Identification cards — Test methods — Part 1: General characteristics

AMENDMENT 1

Amendment 1 to ISO/IEC 10373-1 was prepared by Joint Technical Committee JTC1, *Information technology*, Subcommittee SC 17, *Cards and personal identification*.

Figure Amd.1-1 — ICC-holder

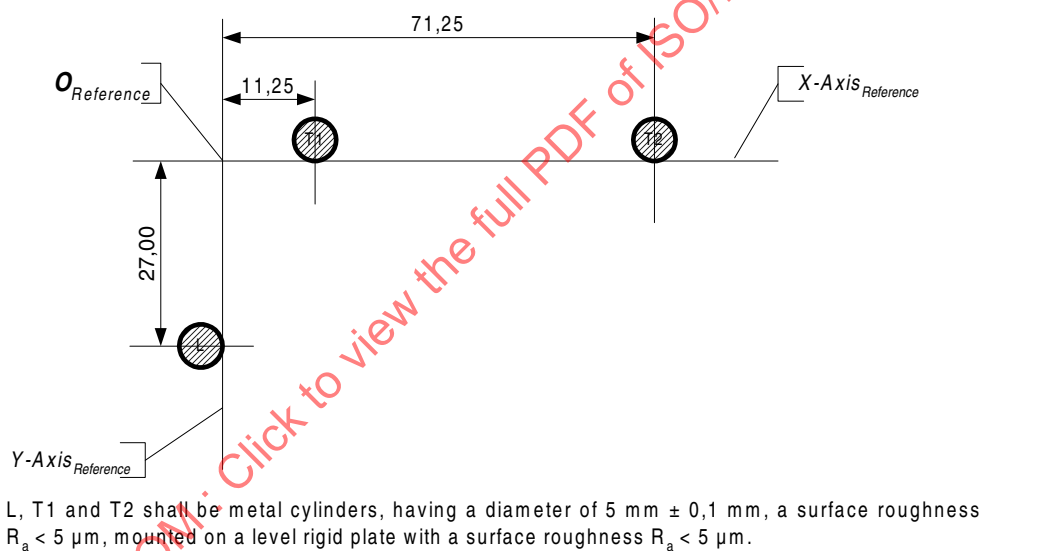
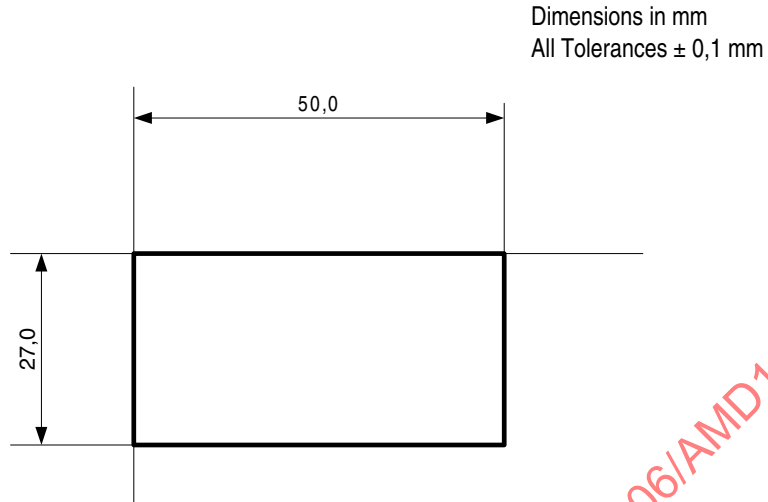
4.7.2 Default ICC-holder and reference axes:

The default ICC holder shall comply with Figure Amd.1-1:

Figure Amd.1-2 — Flattening plate

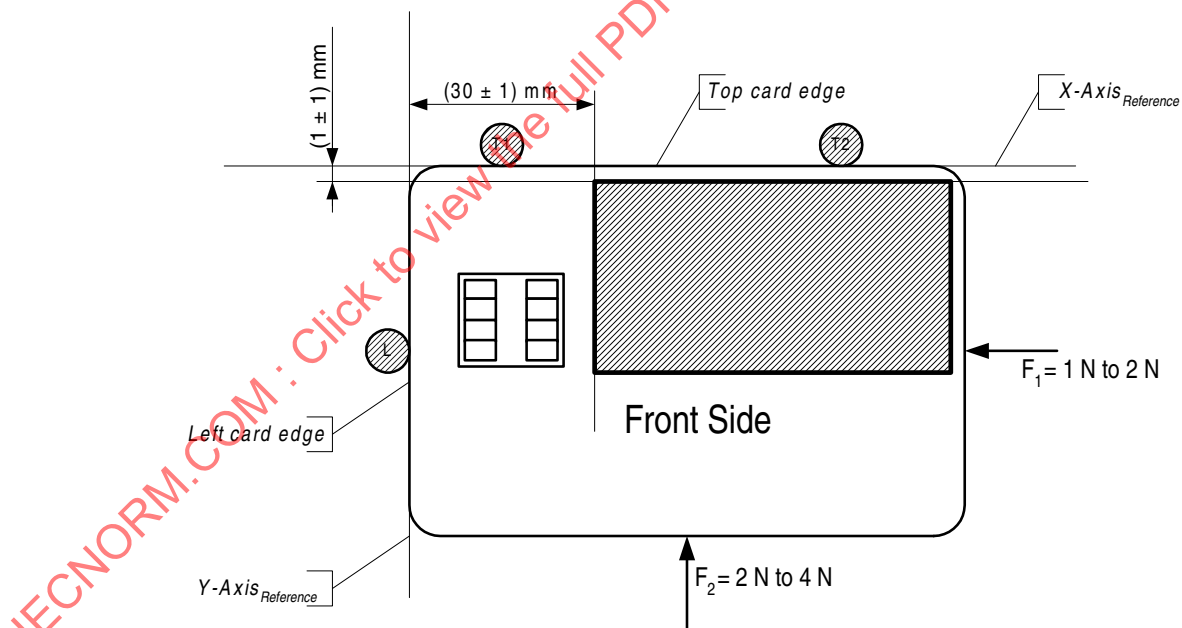
The flattening plate shall comply with Figure Amd.1-2:

The surface roughness of the flattening plate shall be $R_a < 5 \mu\text{m}$.

Figure Amd.1-4 — ESD test circuit

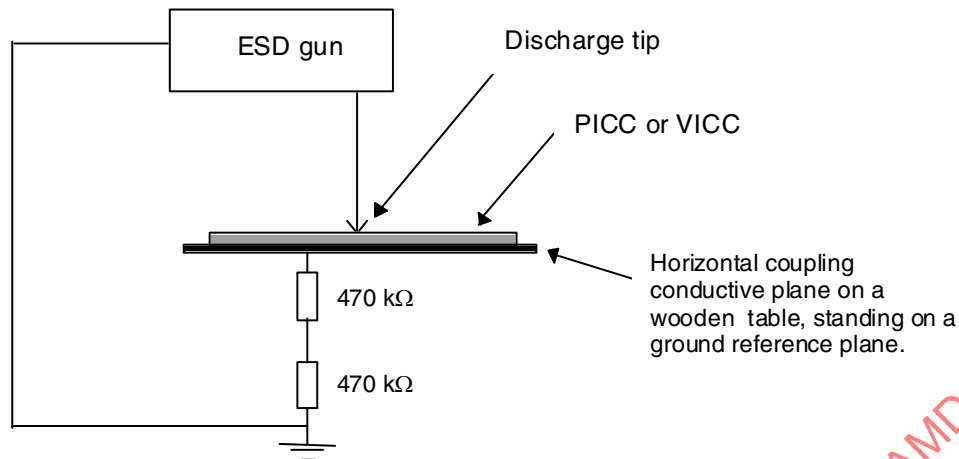
Connect the ground pin of the apparatus to the conductive plate upon which the PICC or VIVV is placed (see Figure Amd.1-4).

Figure Amd.1-5 — Test zones on PICC or VICC for ESD test

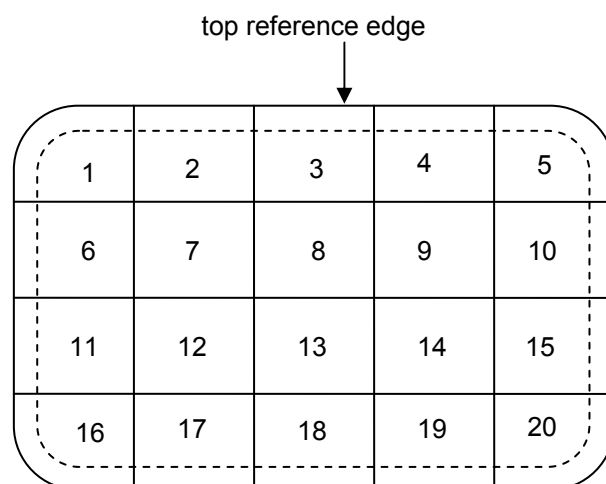
Apply the discharge successively in normal polarity to each of the 20 test zones shown in Figure Amd.1-5 ensuring that the discharge tip is not applied within 6 mm of the card perimeter (see the dashed boundary line in Figure Amd.1-5) and allowing a cool-down period between successive pulses of at least 10 s.

WARNING — If the PICC or VICC includes contacts, the contacts shall face up and the zone which includes contacts shall not be exposed to this discharge.

Figure Amd.1-6 — Test prods

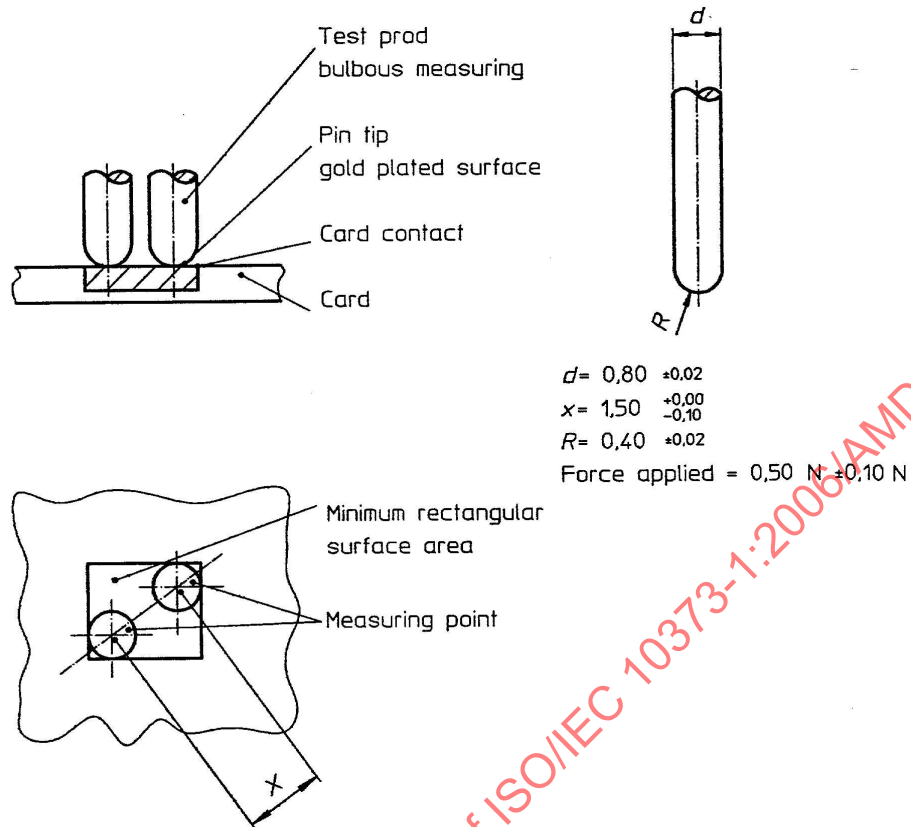
Ohmmeter with a range from 10 m Ω to 2 Ω having an accuracy of ± 2 m Ω and test prods as defined in Figure Amd.1-6. The measurement current shall be less than or equal to 100 mA and the measurement voltage shall be less than or equal to 20 mV.

Figure Amd.1-7 — Measurement tip

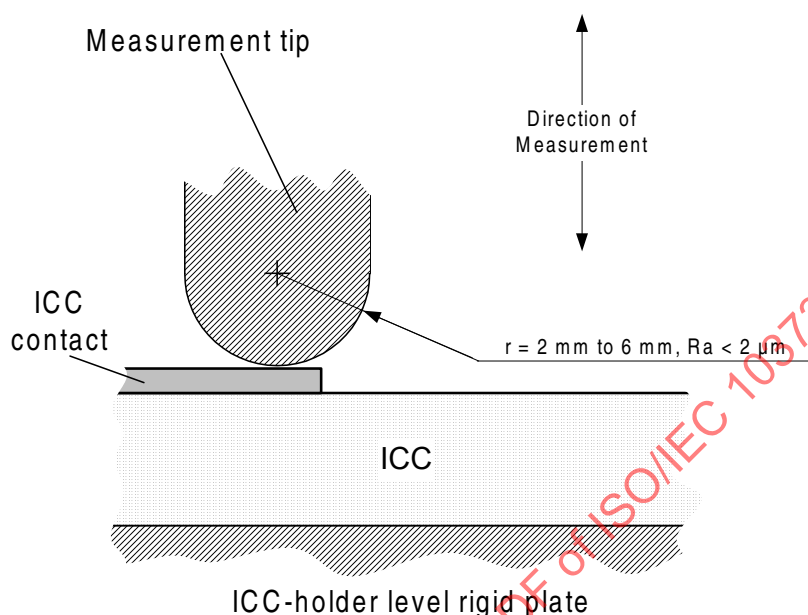
A measurement device capable of measuring the perpendicular distance between the upper surface of the level rigid plate of the ICC-holder and the upper surface of an ICC placed on the ICC-holder with an accuracy of 0,01 mm. The area of measurement shall be 2,5 mm wider in all directions than the area covered by the contact metallization of the ICC to be tested. The measurement tip shall be as shown in Figure Amd.1-7:

Figure Amd.1-8 — Measurement line across contacts C1 and C5

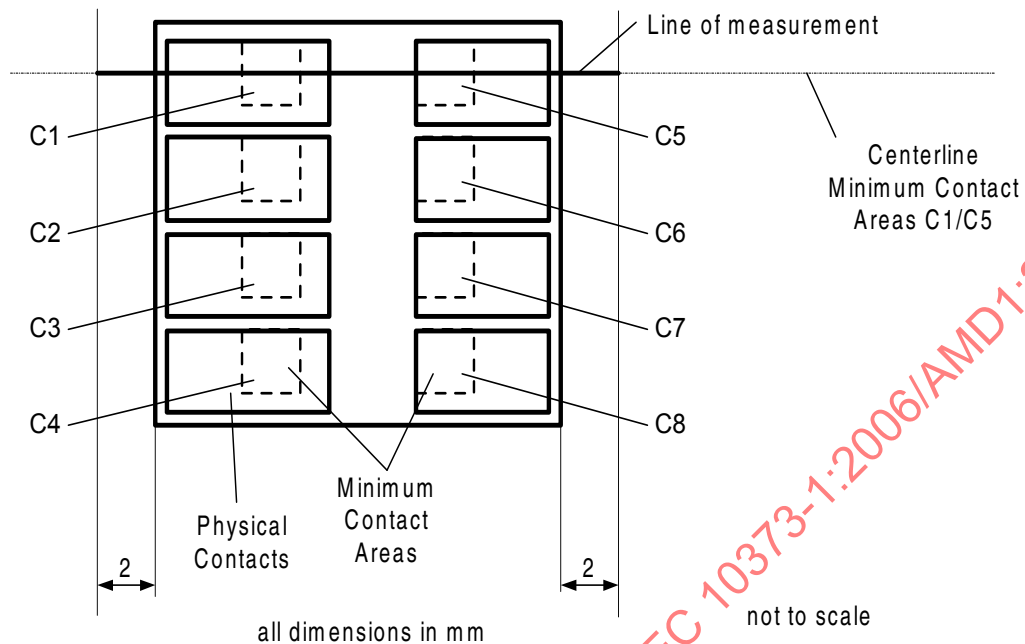
- Mount the ICC in the default measurement position as defined in 4.6.1.
- Construct a measurement line on the surface of the ICC along the centerline of the minimum contact areas C1 and C5, beginning and ending at a distance of 2 mm of the metallized contact surface (Figure Amd.1-8).

Figure Amd.1-9 — 3 wheel test principle

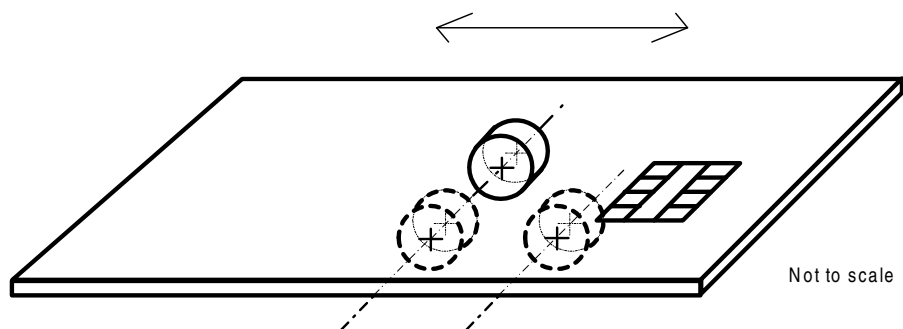
The principle of the apparatus is shown in Figure Amd.1-9. It comprises three wheels, one above and two below the ICC. The ICC is moved cyclically between the three wheels, so that the contact area is repeatedly exposed to the forces exerted by the wheels.
